Comments on the Draft Report
by the California Council on Science and Technology
"Health Impacts of Radio Frequency from Smart Meters"

by Daniel Hirsch[1]
31 January 2011

Figure A. Comparison of Radio-Frequency Levels to the Whole Body from Various Sources in $\mu W/cm^2$ over time [corrected for assumed duty cycle and whole body exposure extrapolated from assumed cell phone dose at ear].

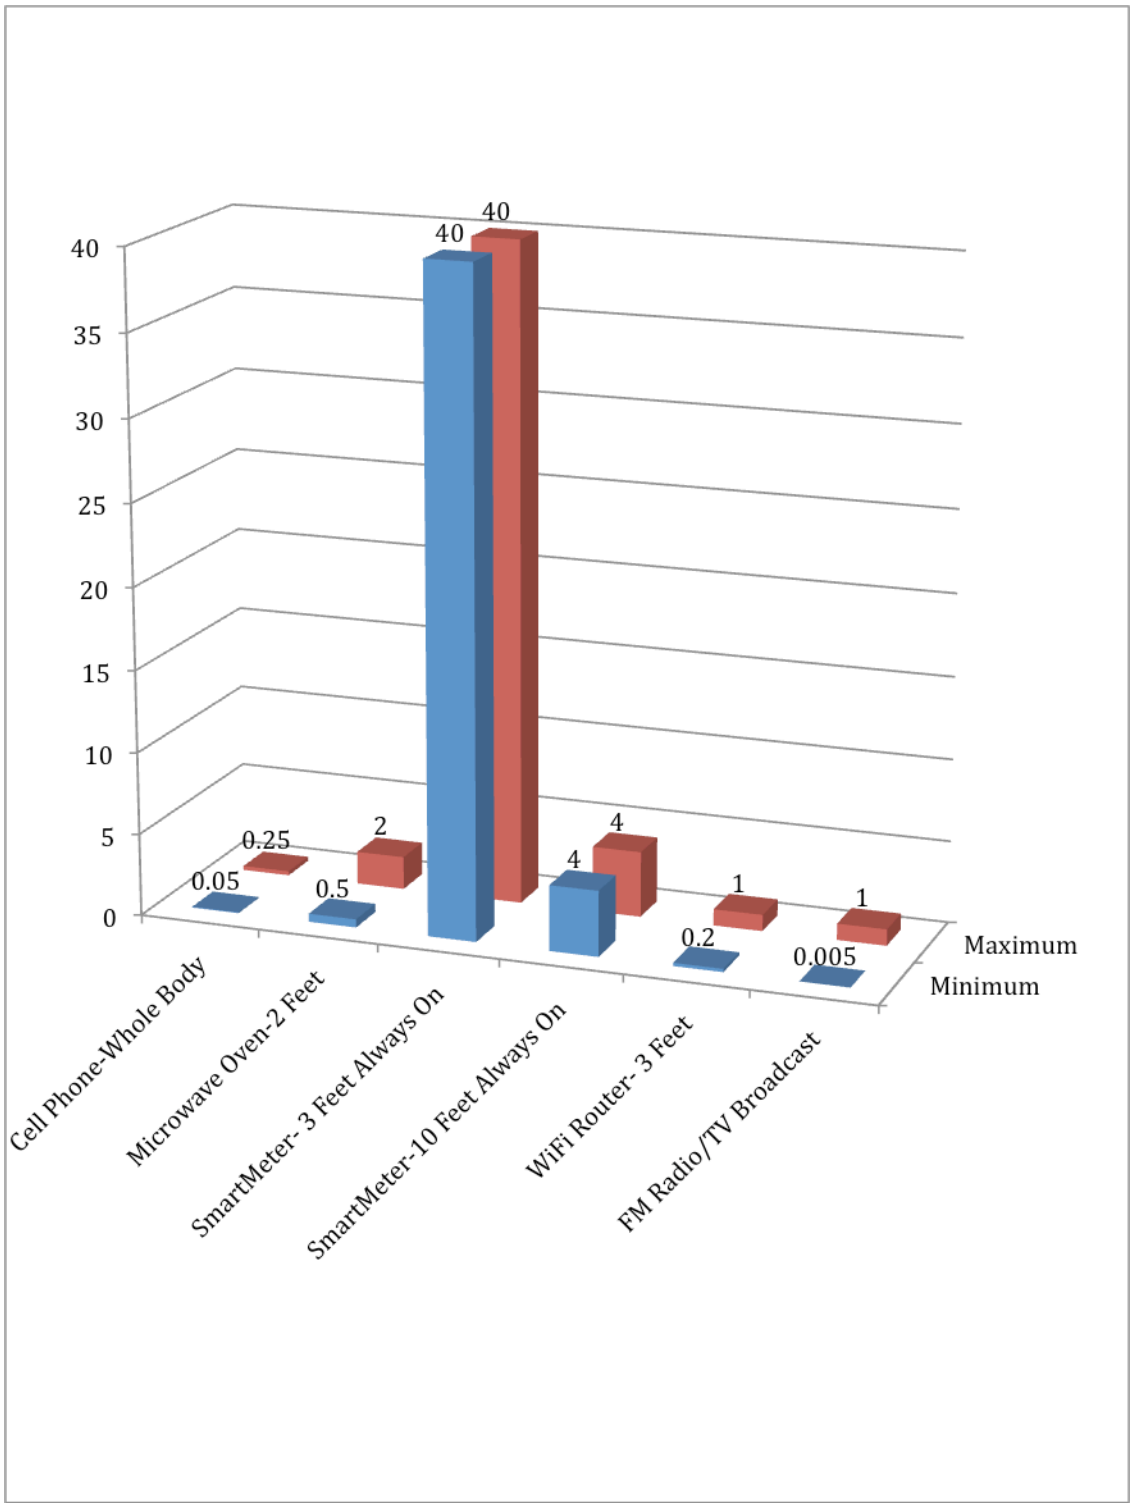
A summary figure below shows how rough estimates of the effect of those corrections suggest SmartMeters may produce cumulative whole body exposures far higher than that of cell phones or microwave ovens.

It is strongly recommended that CCST revise its Draft Report and conduct actual measurements of cell phone, microwave oven, and SmartMeter RF cumulative whole body power densities. If measurements aren't made, then rigorous calculations correcting for cell phone and microwave oven duty cycles and whole body exposures should be made.

Figure 1: Graph from CCST Report in $\mu W/cm^2$—uncorrected for whole body exposure or duty cycle

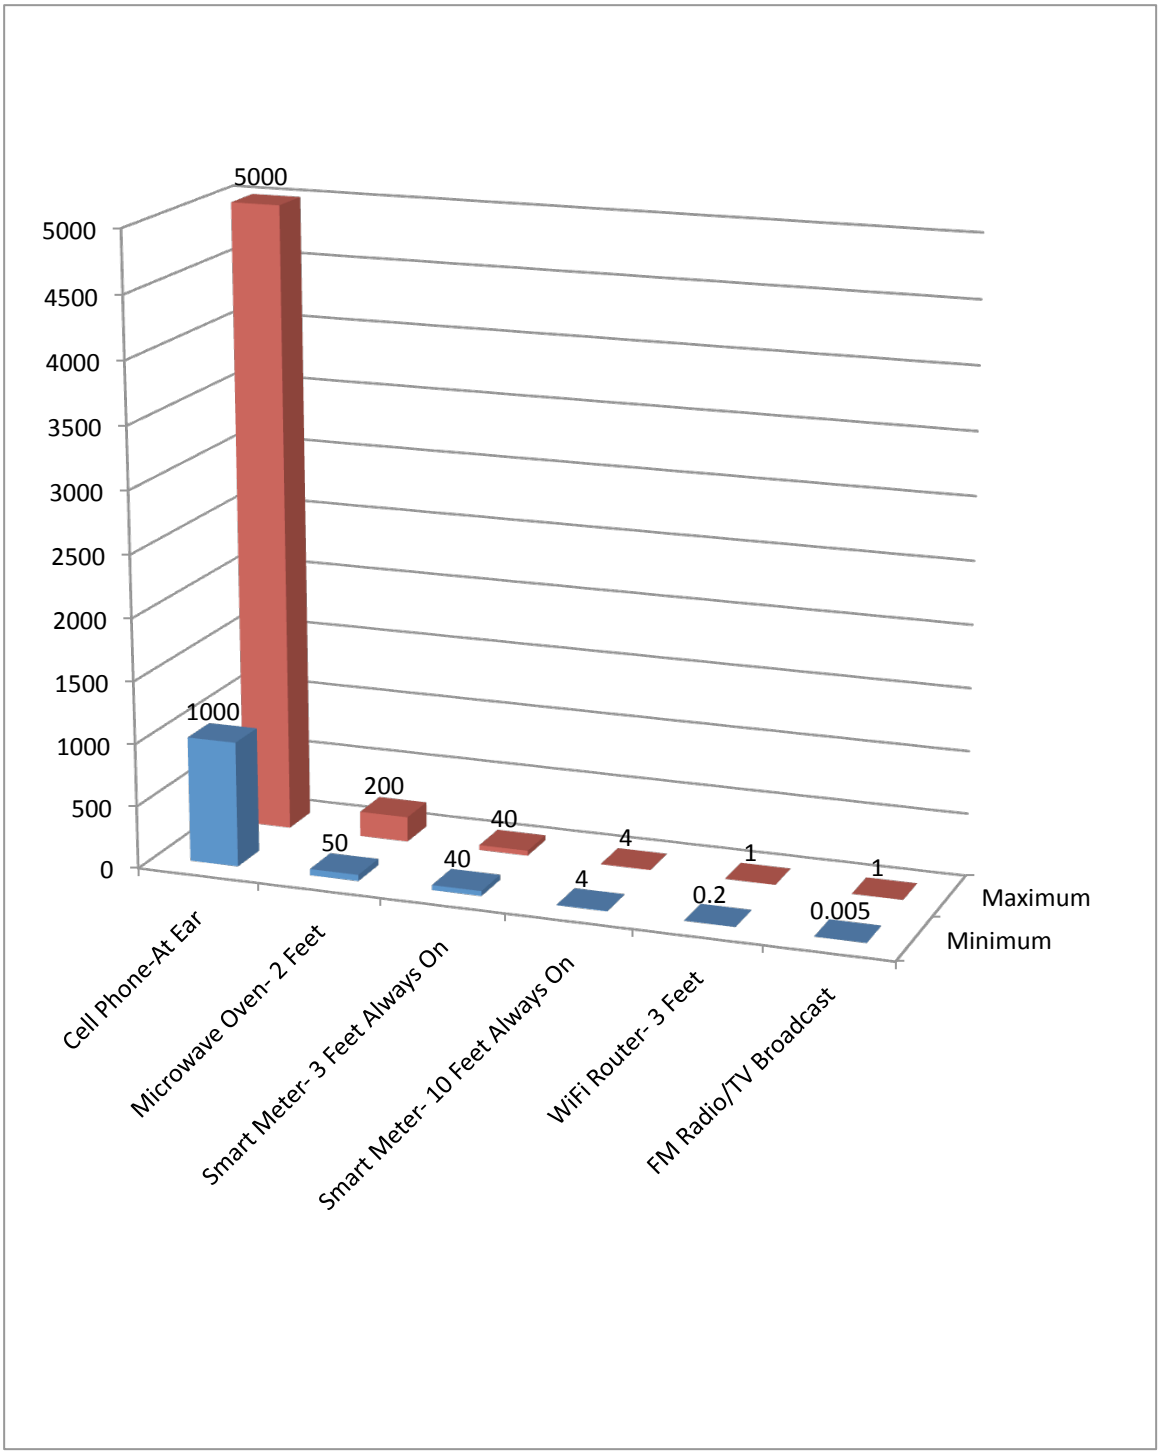
Figure 1 is simply the CCST Figure 1, which in turn was largely taken from the estimates in the EPRI pamphlet. Units were simply converted by CCST from mW/cm^2 to $\mu W/cm^2$ and it corrected the duty cycle for the SmartMeter, otherwise the data are unchanged from EPRI's estimates. One will note that the estimated exposure from the cell phone is just to the ear, in direct contact with the cell phone, whereas the other comparisons, including the SmartMeter, are for whole body exposures, and that the duty cycle of the cell phone and microwave oven were not corrected. In other words, the chart compares a SmartMeter that is always on with a cell phone or microwave oven when they are being used, even though 99% of the time they are not in use. This overestimates the cumulative exposure by a factor of 100 for the cell phone and microwave oven, and dramatically skews the comparison.

Figure 2. Comparison of Radio-Frequency Levels from Various Sources in $\mu W/cm^2$ over time [corrected only for assumed duty cycle).

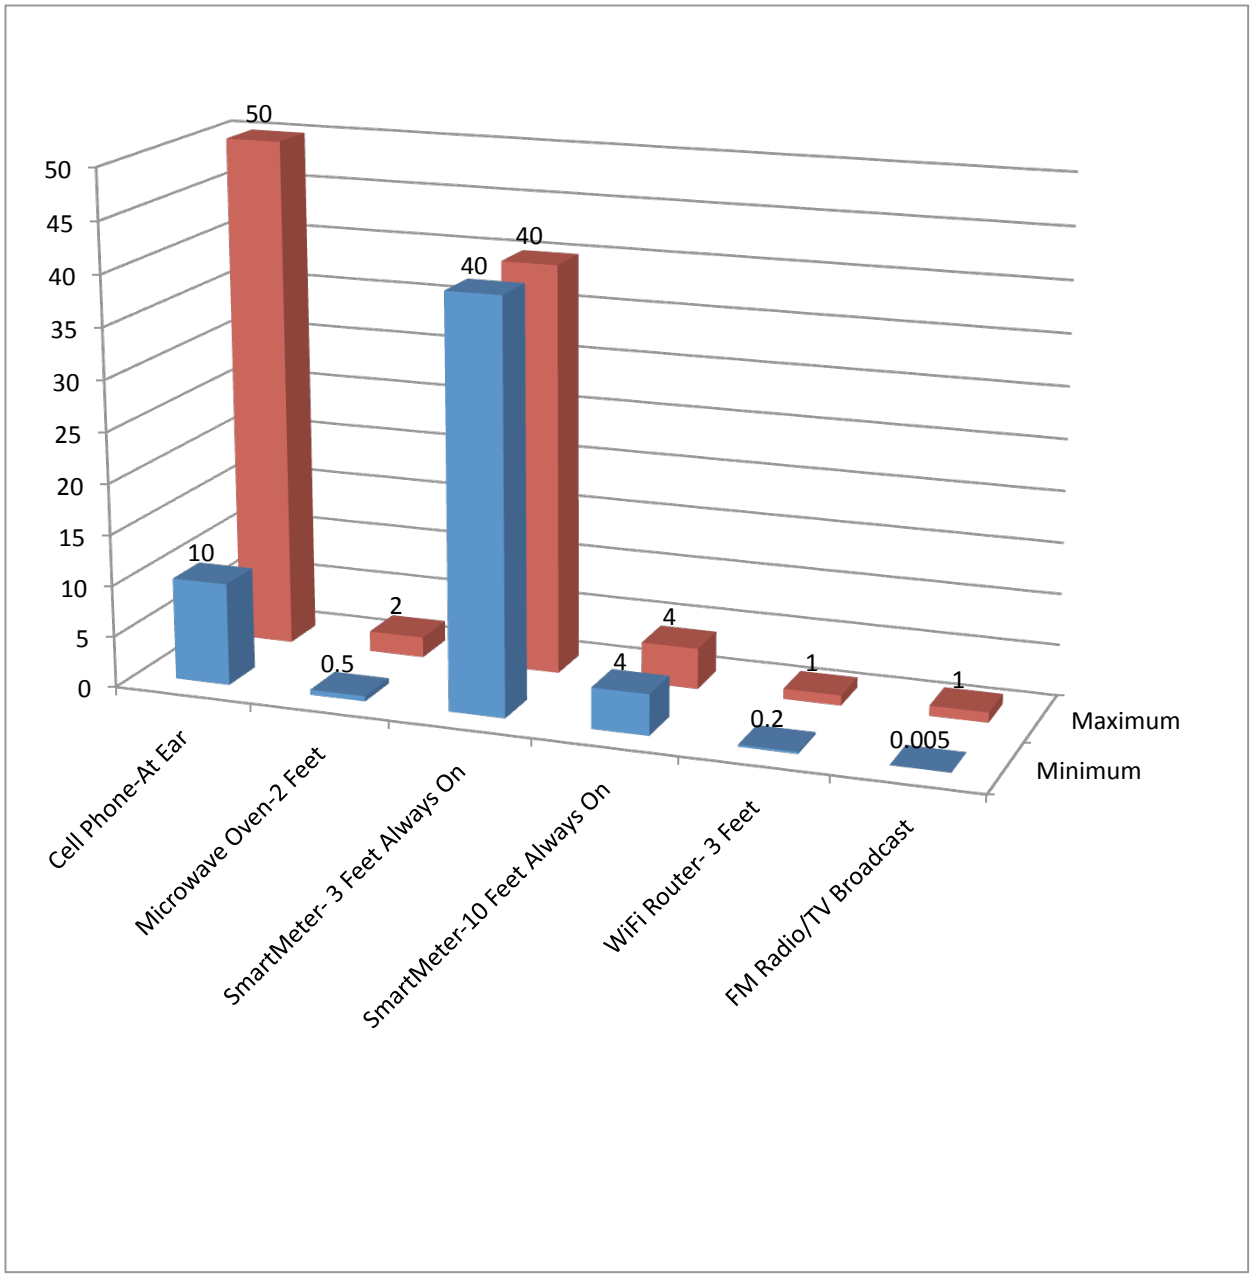
Figure 2 fixes the error regarding duty cycle for the cell phone and microwave oven, markedly altering the comparison. The minimum cumulative exposure over time from the SmartMeter at 3 feet is 80 times the minimum cumulative exposure from the microwave oven and four times the minimum cumulative exposure from the cell phone, for example. This does not involve any correction of the while-on exposure values for either the cell phone or microwave oven, only the duty cycle factor.

Figure 3. Comparison of Radio-Frequency Levels to the Whole Body from Various Sources in $\mu W/cm^2$ over time [corrected for assumed duty cycle and whole body exposure extrapolated from assumed cell phone dose at ear].

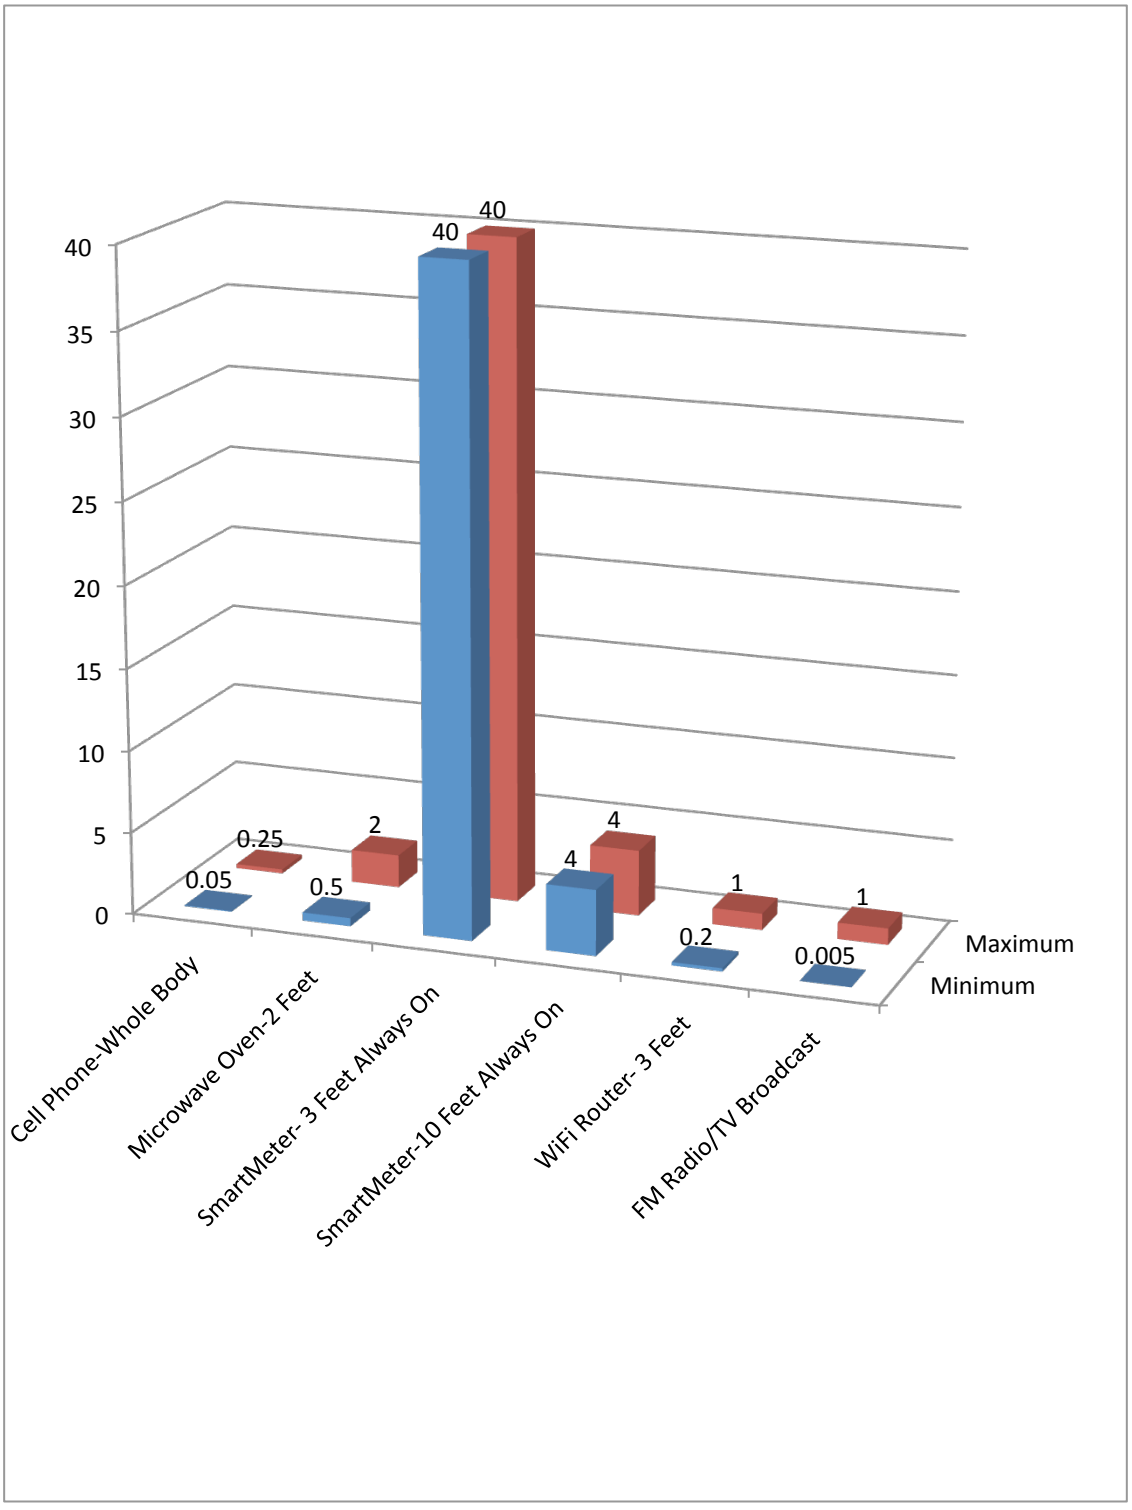
Figure 3 provides a very rough approximation of the correction of the cell phone at the ear estimate to a whole body estimate so it is comparable to the whole body estimate for the SmartMeter. *It should be stressed that neither this estimate nor that in Figure 4 using a different approach is intended to be a definitive figure, but is intended to be exemplary of the kind of change to the comparison a detailed analysis may produce. It is my recommendation that CCST carefully measure, or at minimum thoroughly calculate, the average power density over the whole body from a cell phone held at the ear. We here have made two very rough estimates just to make the point what a far more detailed analysis may show.*

Averaging over the full potentially exposed surface area of the body (presuming only half the body surface could be exposed to the cell phone from any one angle), the whole body exposure would be approximately on average 0.25 mW/cm^2 given the maximum value to the ear of 5 mW/cm^2 put forward by EPRI and the CCST draft report and correcting as well for the duty cycle. **The SmartMeter thus would produce 160 times more cumulative whole body exposure than the cell phone assuming this estimate for whole body exposure.** This is shown in Figure 3.[3]

Figure 4. Comparison of Radio-Frequency Levels to the Whole Body from Various Sources in $\mu W/cm^2$ over time [corrected for assumed duty cycle and whole body exposure extrapolated from EPRI/CCST SmartMeter estimated levels at 3 feet].

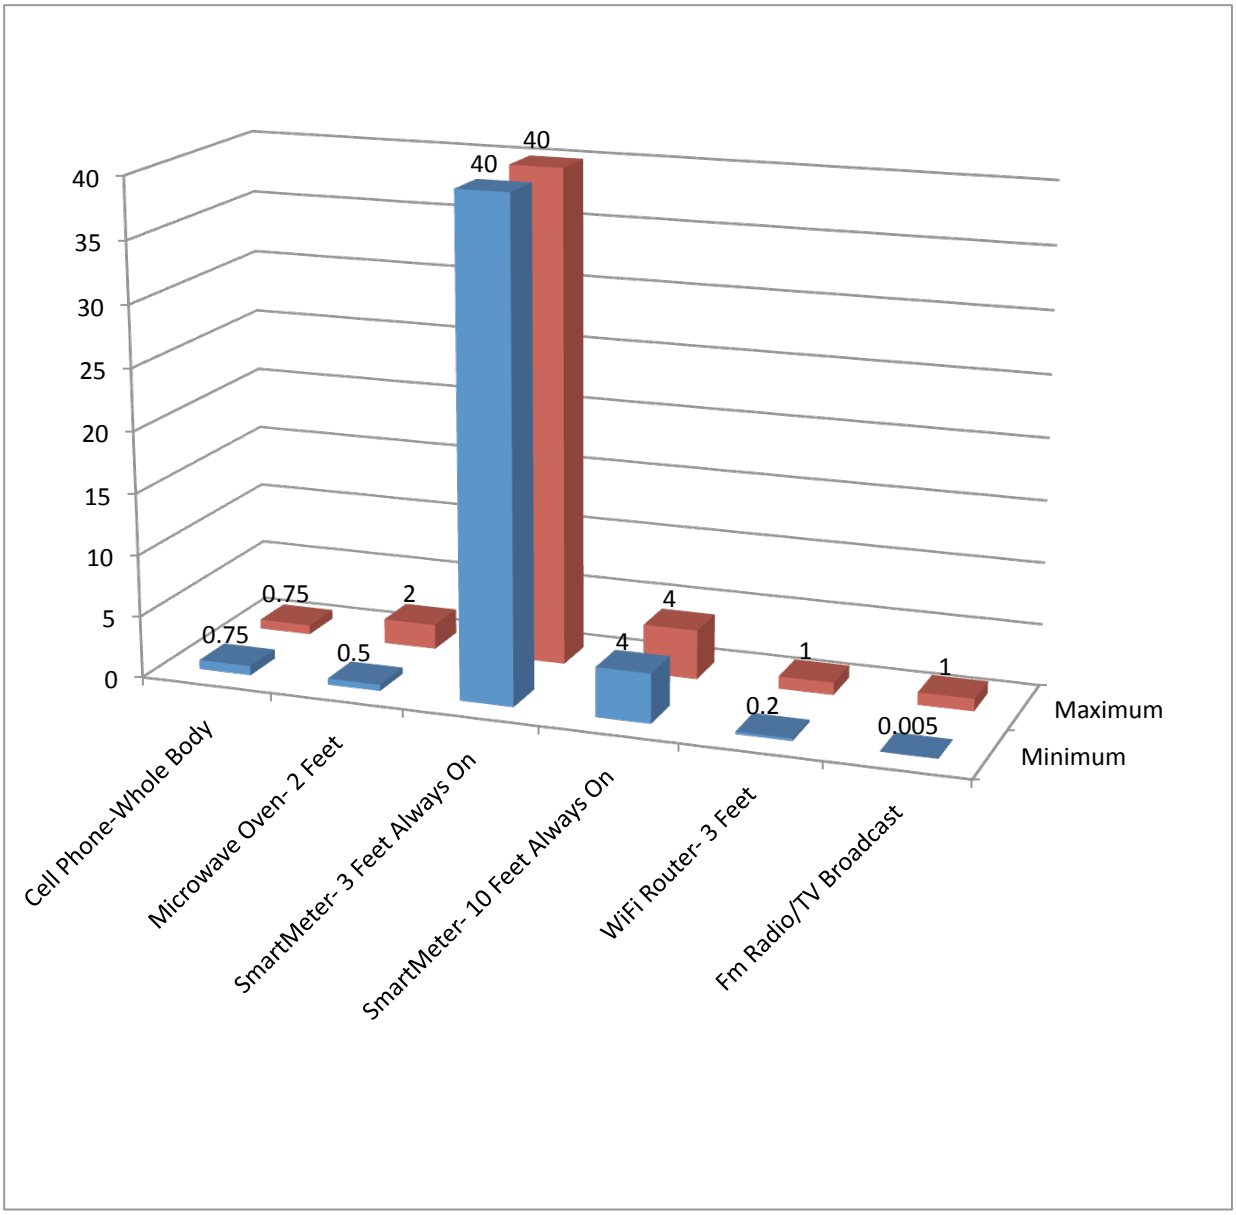
Since the EPRI estimate for cell phone peak power density at the ear is unexplained as to its derivation, we have also made a very rough estimate of whole body exposure from a cell phone from an independent line of calculation. Taking the values EPRI (and thereby CCST) put forward for exposure at three feet from a 250 mW SmartMeter, and noting that EPRI assumed the cell phone would also be 250mW, one can make a rough estimate of power density for the whole body from a cell phone held at the head. The exposure at one's waist would be approximately three feet from the source, just as in the assumed case of the SmartMeter. Presuming that the dose falls off as the inverse square of the distance, a very rough estimate of power density averaged over half the surface of the whole body, and taking into account duty cycle, yields a cumulative cell phone whole body power density of roughly 0.75 $\mu W/cm^2$. **Using this way of estimating suggests the SmartMeter would produce 50 times the cumulative whole body exposure as a cell phone.** The results of this comparison are found in Figure 4.
